Memorandum

4 November 2019

To	Douglas Shire Council and Department of State Development, Manufacturing, Infrastructure and Planning		
From	Sarah Wilson - GHD	Tel	+61 7 5413 8133
Subject	Response to information request from Douglas Shire Council (DSC) and Department of State Development, Manufacturing, Infrastructure and Planning (DSDMIP) Wangetti Trail SP1 - Combined Development Application Response to request for information 1909-13127 SRA	Job no.	4132458

Plate 1 Example of ballast rock used to construct the trail

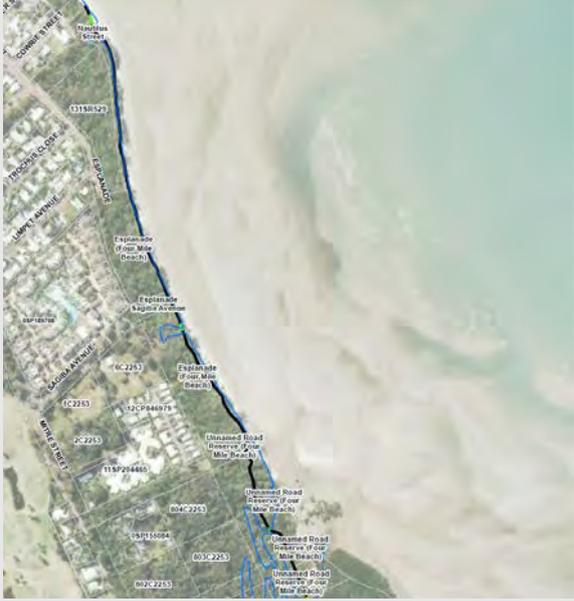
Item 2 (c) Identify all locations where crushed rock will be used to construct the track and any creek crossings where rocks are proposed.

Table 3 provides a description of the type of material that will be used to construct the track following advice provided by the design team and trail builders, who have previously undertaken surveys of the project area. It has been confirmed that fine crushed rock will not be used to construct the track or any creek crossings within SP1 and boulders will be not be used within waterways for SP1 project area. Where the contractor determines it to be appropriate, ballast rock will be utilised to create a firm foundation for the trail (refer to Plate 1). This will be placed under the existing surface level, leaving the final trail to be at surface level. Areas that require ballast rock will be determined on site by the contractor.

Refer to the response provided to Item 2(c) in Section 2.1. Details have been provided in Table 3 of the type of material that will be used to construct the trail, following advice received from the design team and trail builders. Crushed rock will not be used to construct the track or any creek crossings within SP1. Where sections of the trail require vegetation clearing, ballast rock will be placed under the existing surface level to create a firm foundation for the trail as shown in Plate 1.

Figure 1 Map showing the alternative options considered for SP1

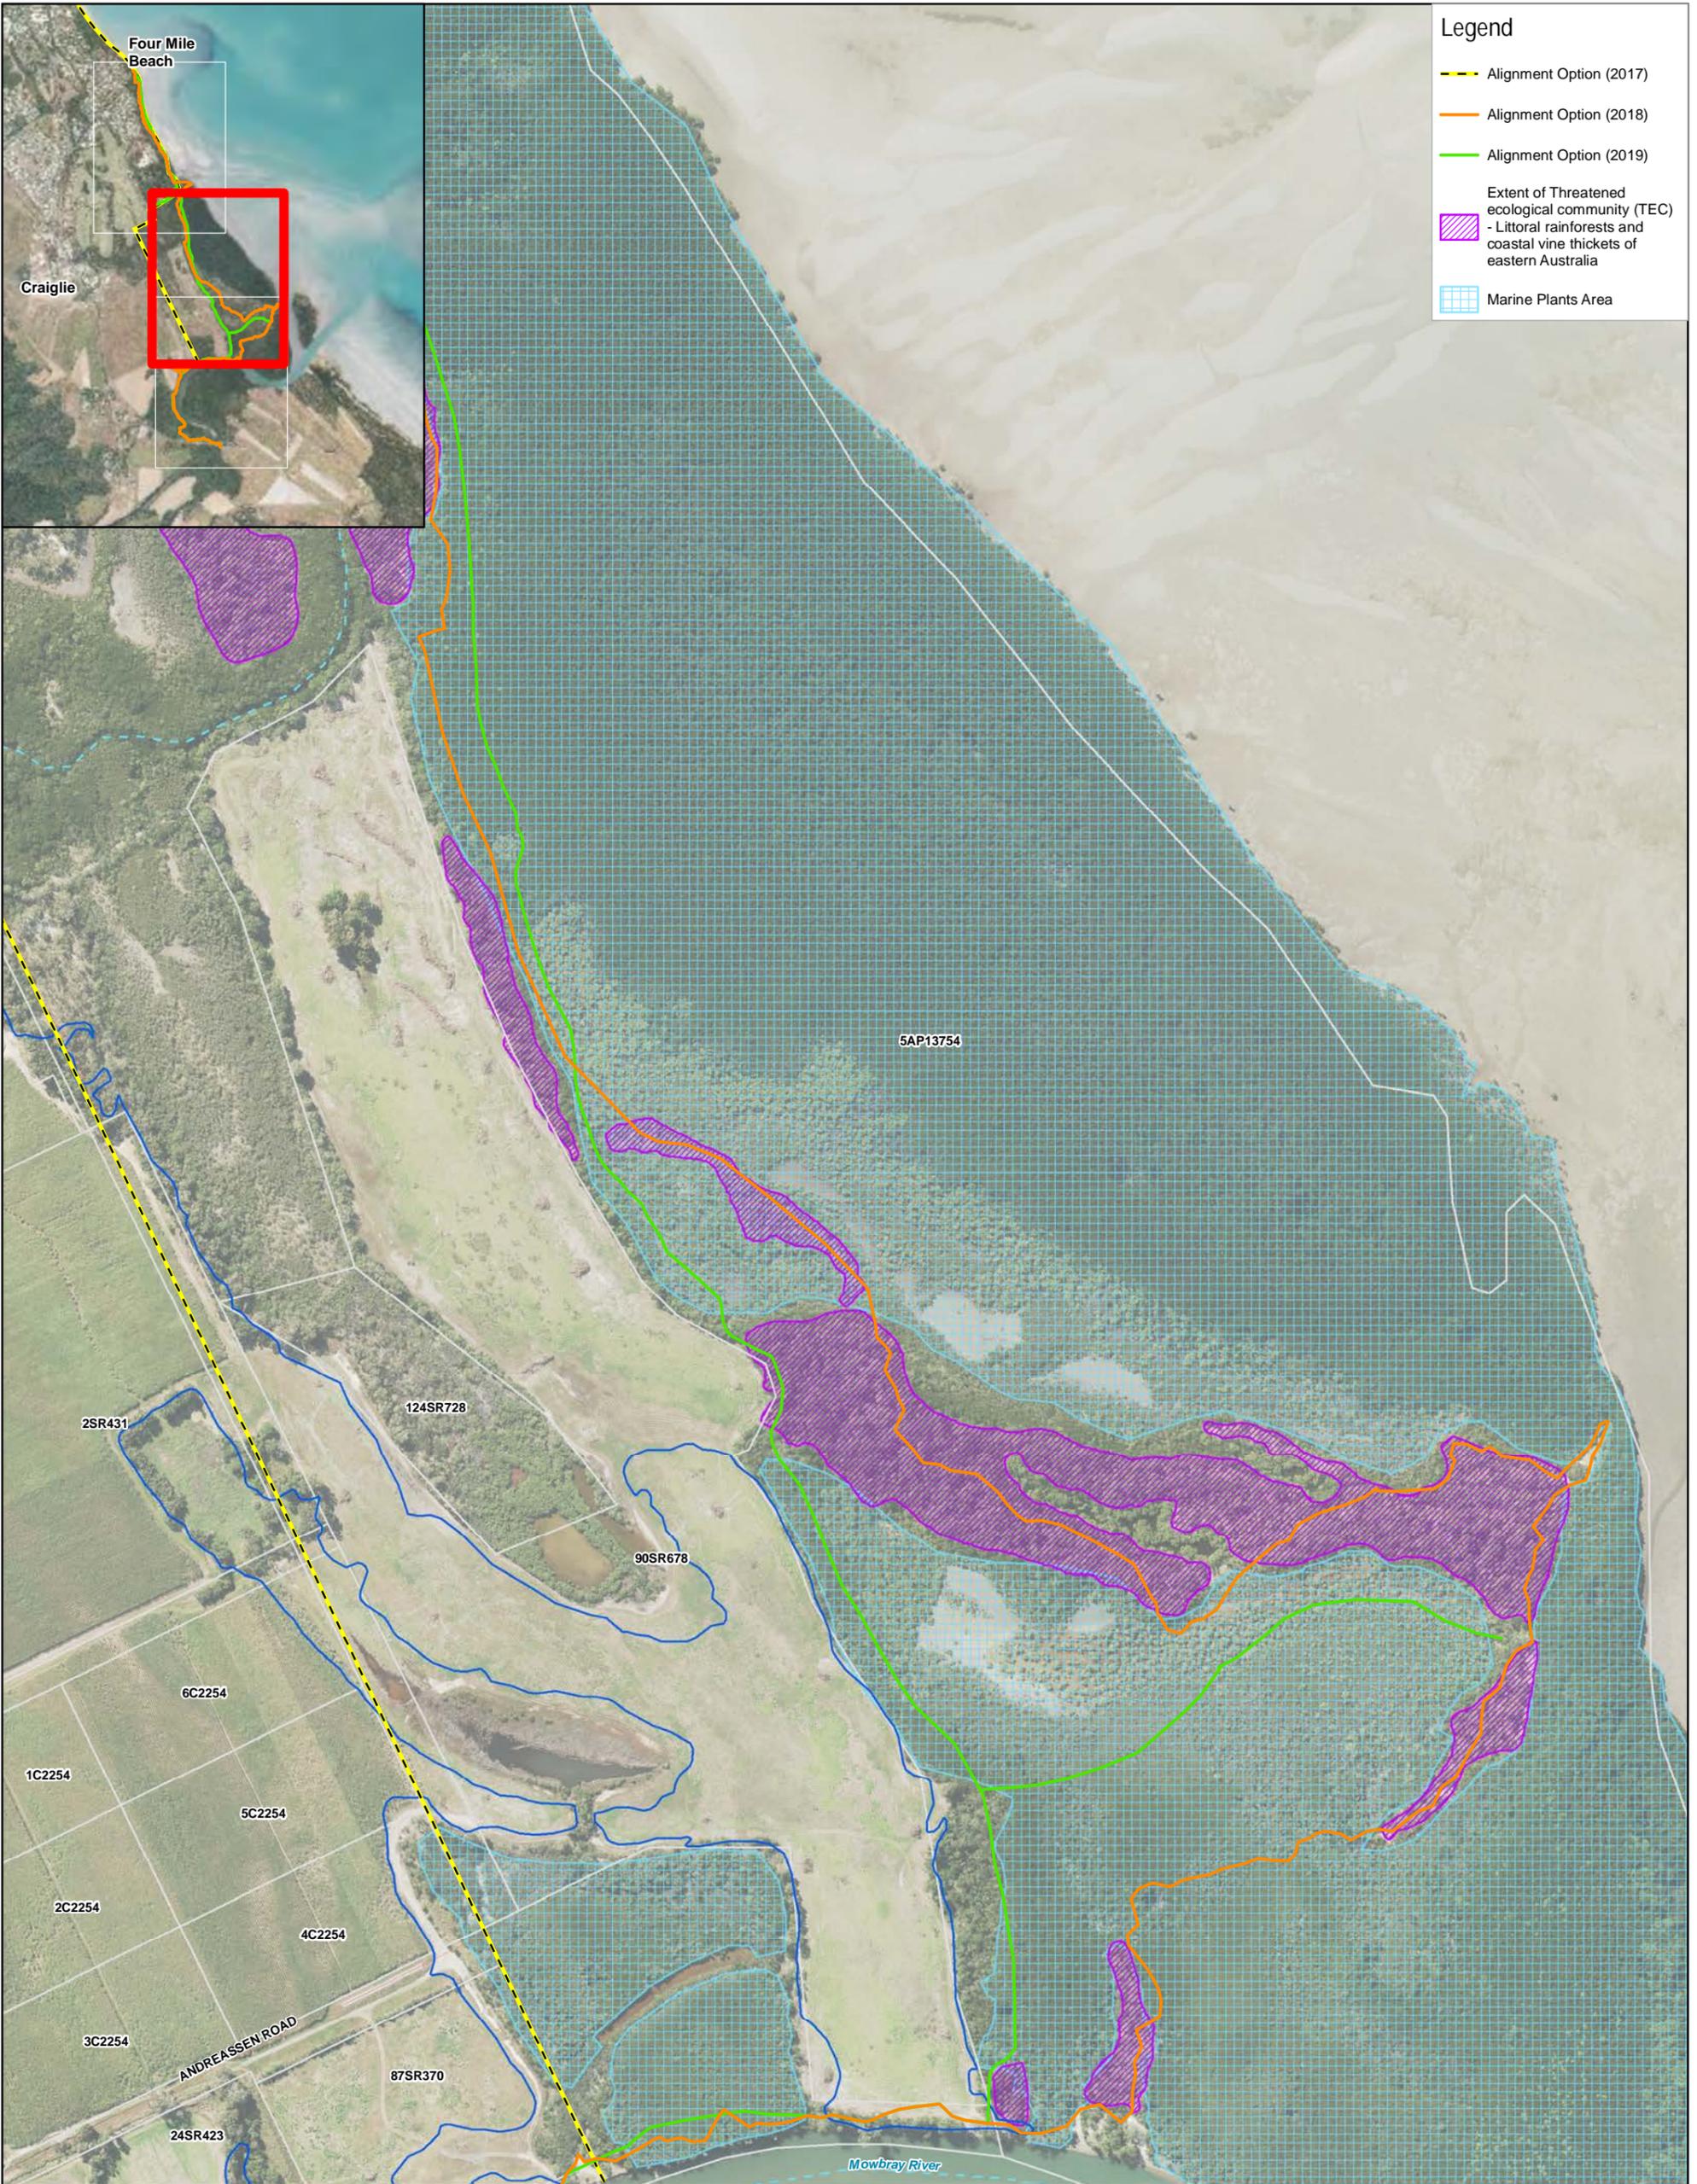
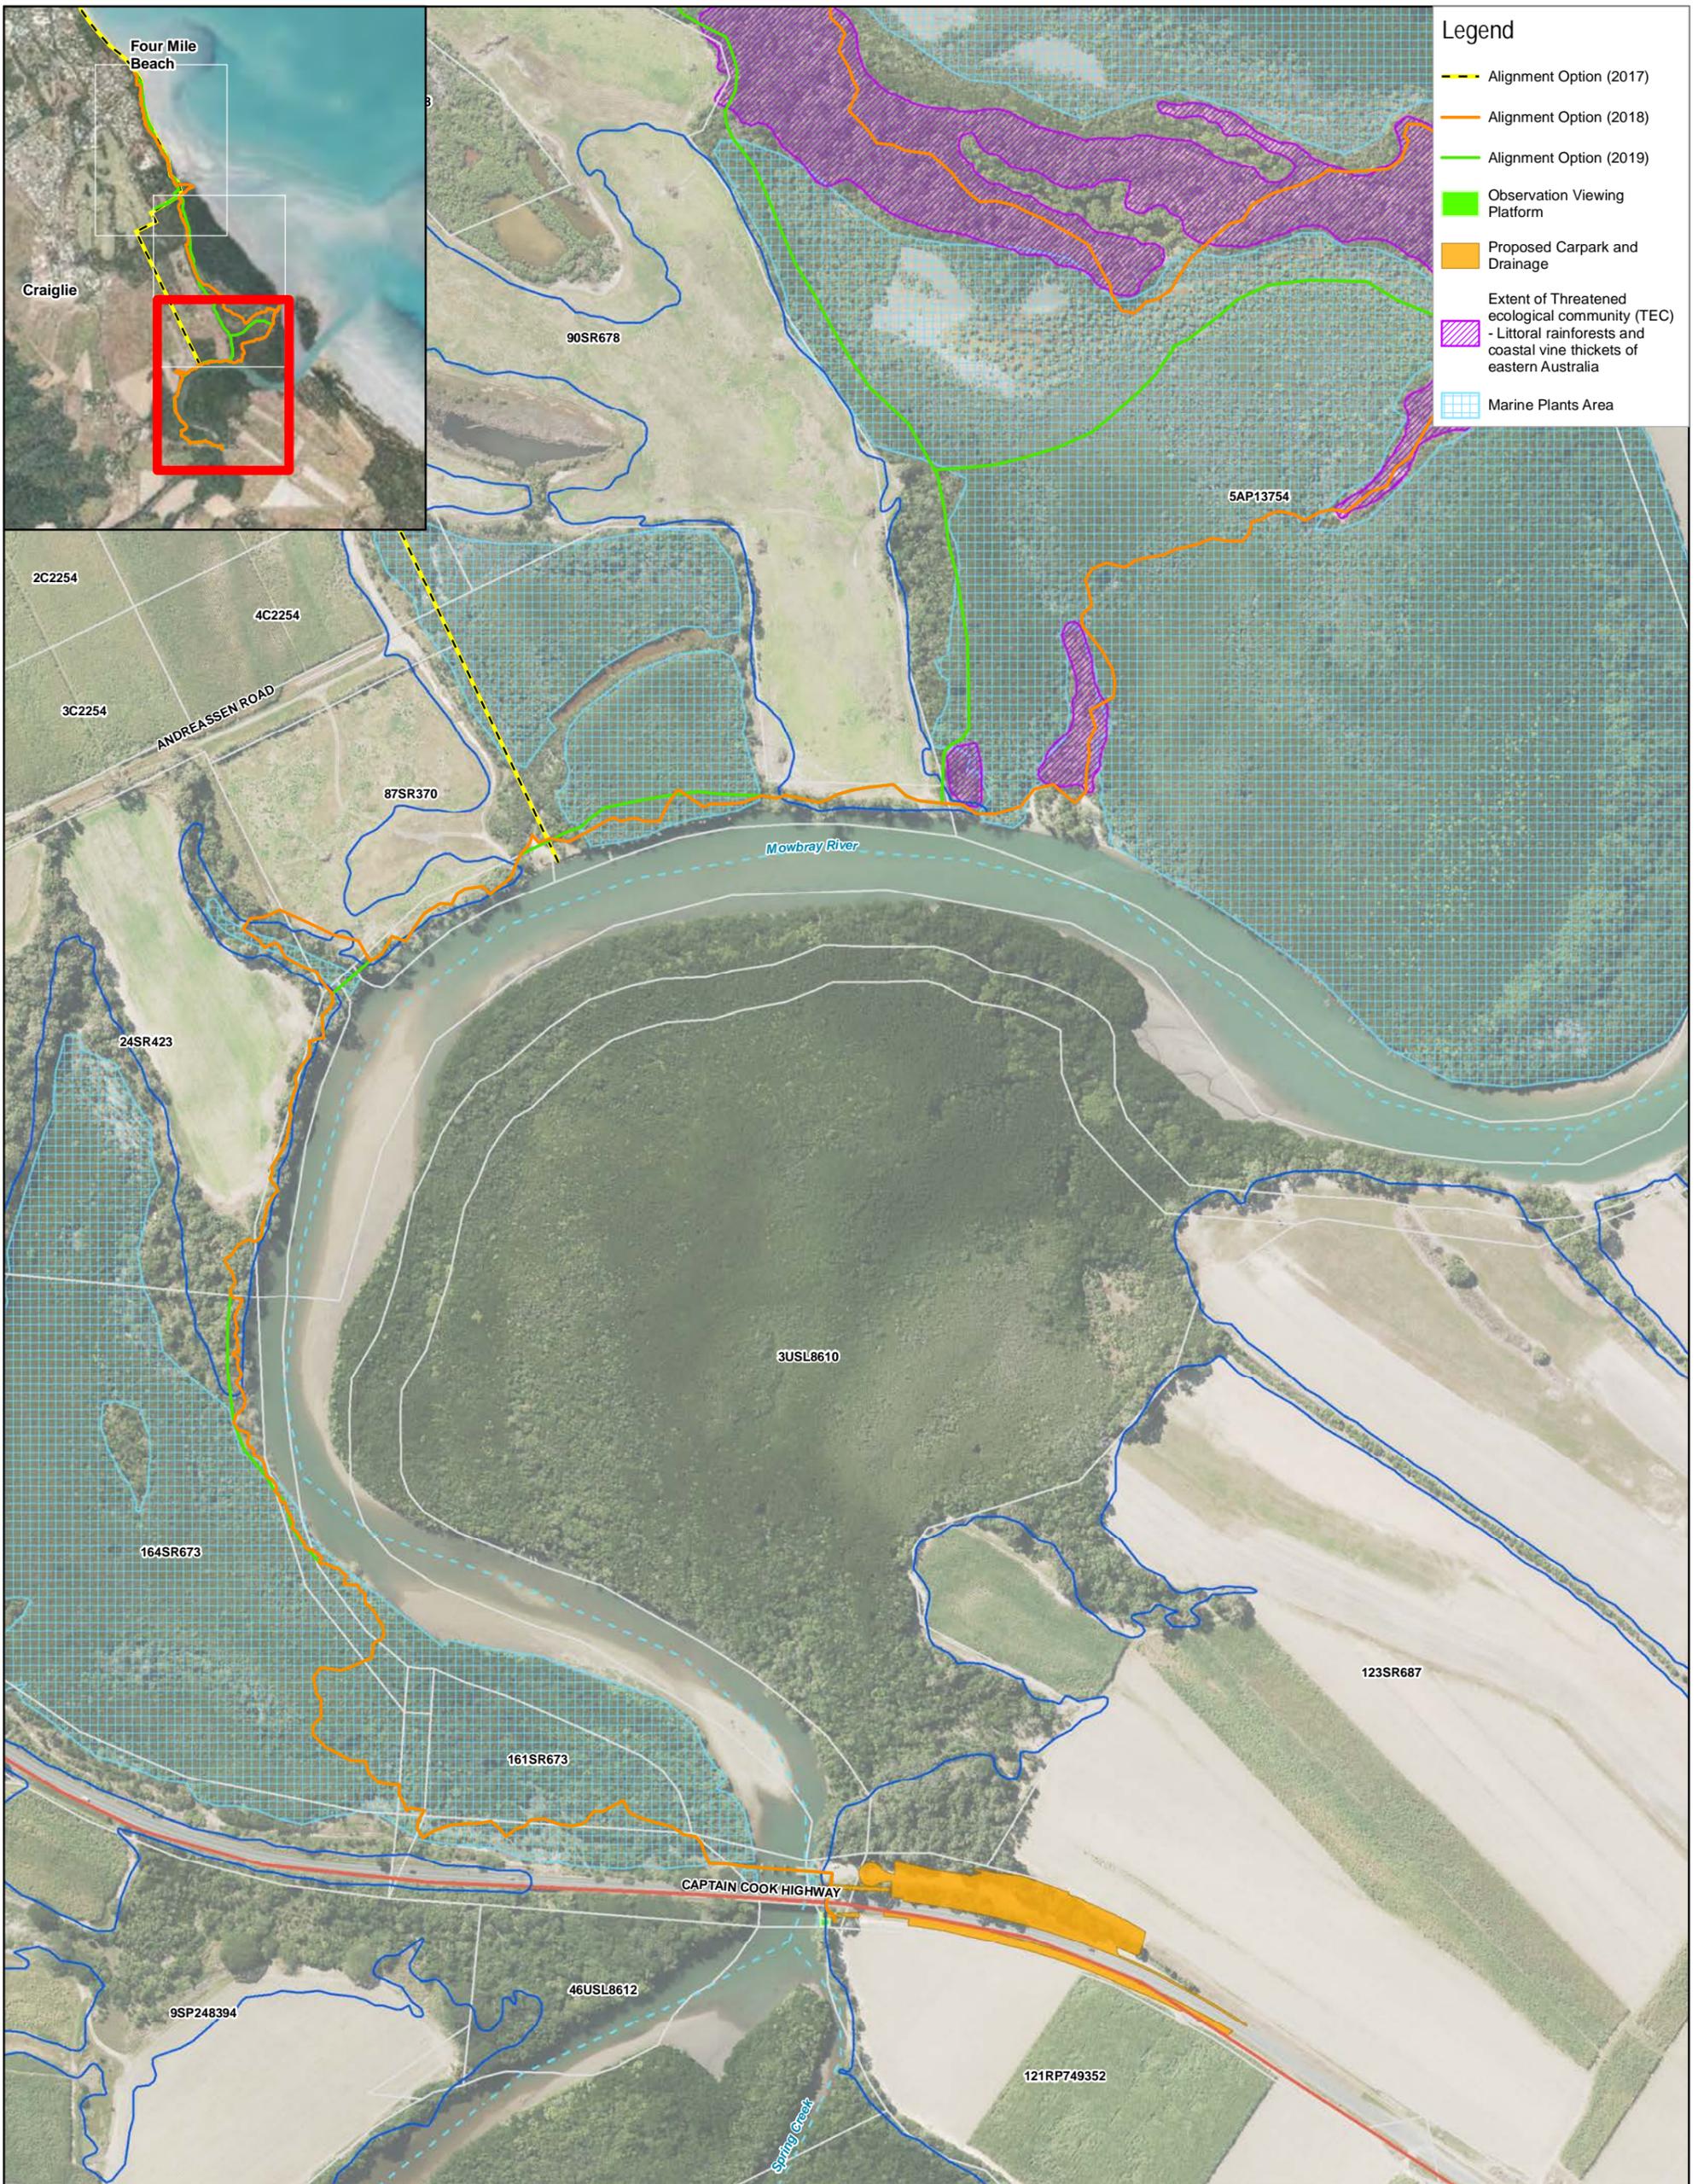
- Identify on scaled maps the trail alignment for Alternative A and Alternative B and provide the permanent and temporary marine plant disturbance areas in meters squares (m²).
- Demonstrate that no alternative trail alignments or construction alternatives exist that will avoid impacts on marine plants and fisheries resources (i.e. raised boardwalk).
- Discuss why areas of cleared land, existing informal tracks and land above the level of HAT within Lot 90 on SR678, Lot 87 on SR370 and Lot 24 on SR423 and the road reserve of Captain Cook Highway have not been used for the trail alignment.

Response to Item 1 (a) Identify on scaled maps the trail alignment for Alternative A and Alternative B and provide the permanent and temporary marine plant disturbance areas in meters squares (m²).

As discussed in Section 3.3 of the SP1 Wangetti Mowbray North Marine Plant Report 2019, multiple alternatives were considered as part of the trail and boardwalk alignment. Alternative A and Alternative B are depicted on Figure 1. A description of the alternative alignments have been discussed in Table 1, including a breakdown of Permanent Marine Plant Disturbance (PMPD) and Temporary Marine Plant Disturbance (TMPD) for alternative alignments vs chosen alignment.

The initial design incorporated a loop where the trail branches off the main trail within Lot 5 on AP13754 (Refer to **Figure 1**). This has been changed to a single branch to substantially reduce the area of impact on marine plants. Other design, maintenance and restoration measures proposed to minimise and mitigate impacts on marine plants are outlined below:
